## Spark Plug Change - 225

### Mariner and Mercury

#### 1994 225 Models

S/N 0D280813 thru 0G001038

NGK BP8H-N-10 Spark Plug

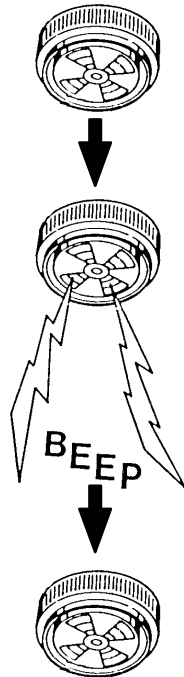
Outboards within the serial numbers listed have NGK BP8H-N-10 spark plugs installed. It is possible to have radio frequency interference (RFI) from the spark plugs that could cause the warning horn to sound intermittently even when the systems are operating correctly. Neither the "TEMP" nor the "OIL" warning light comes on. To correct the sounding of a false warning horn install NGK BPZ8H-N-10 inductor spark plugs. These inductor spark plugs are installed in 225 models beginning with serial number 0G001039.

Possible Intermittent False Horn

NO False Horn

Install BPZ8H-N-10 spark plugs in 225 models s/n 0D280813 thru 0G001038:

- before delivery to the customer or
- if a complaint is received of a false warning horn.
